CORRIGENDUM

Implementation of Beach Management Plan (Phase 1) - Construction of Parking Area and Provision of amenities at Belle Mare public beach

Procurement Reference Number: BA/ONB/3/2021-2022

PROJECT: <div>BEACH MANAGEMENT PLAN</div> <div>BELLE MARE PUBLIC BEACH</div>			
DRG TITLE: <div>PARKING DETAILS</div> <div>PARKING LOT 3</div>			
DRG NO: MD216/G/RD/02		DRWN BY:	SCALE NTS
SERIAL NO: -	REVISION NO: 1	CHKD BY:

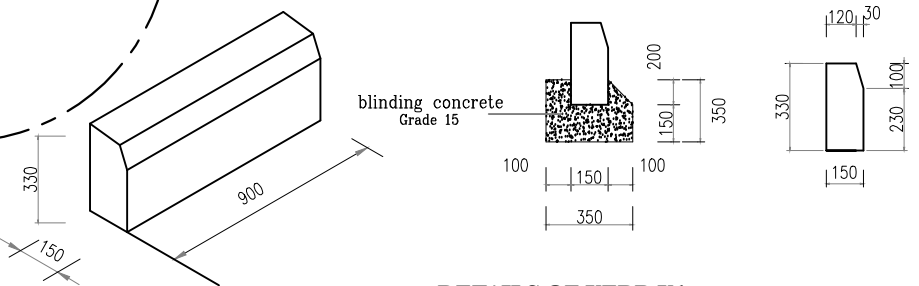
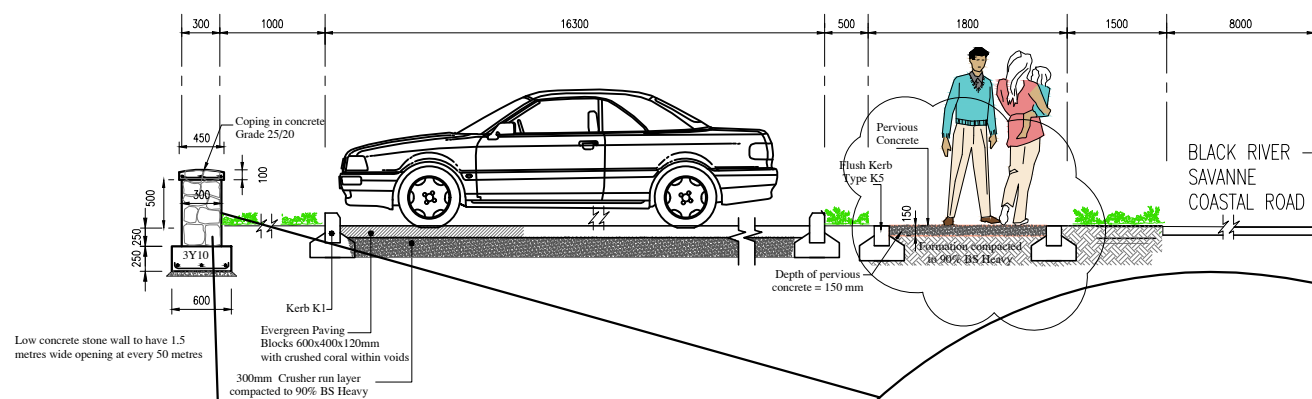
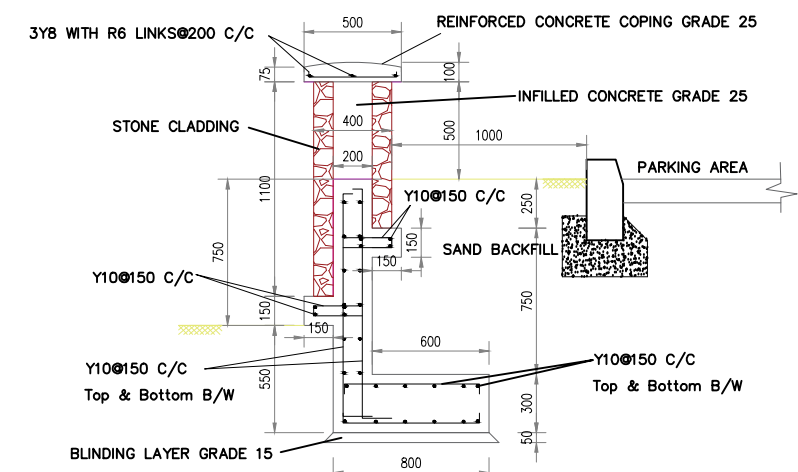
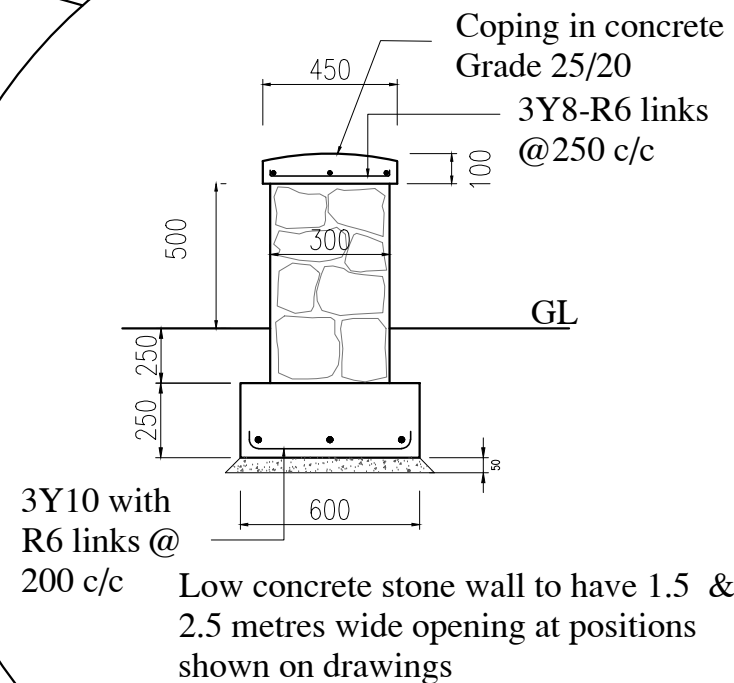
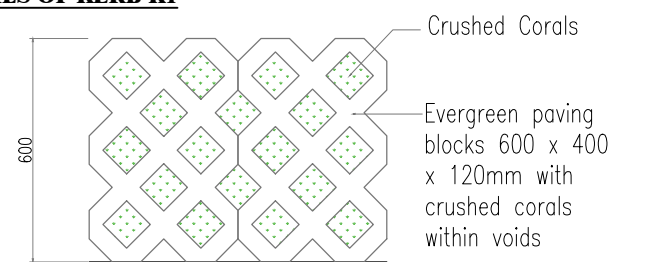
"We note that there is a discrepancy between the bill description and the drawing regarding pervious concrete. The thickness of pervious concrete is 150mm in the bill of quantity whereas the drawing with ref MD216/G/RD/02 illustrates 100mm thick. Please advise"

Potential Bidders are hereby informed that the thickness of pervious concrete is 150mm as specified in Bill of Quantity at Bill item B.7 **whereas in the drawing number MD216/G/RD/02 it should be read as "150mm" instead of 100mm.** A revised drawing is uploaded accordingly.
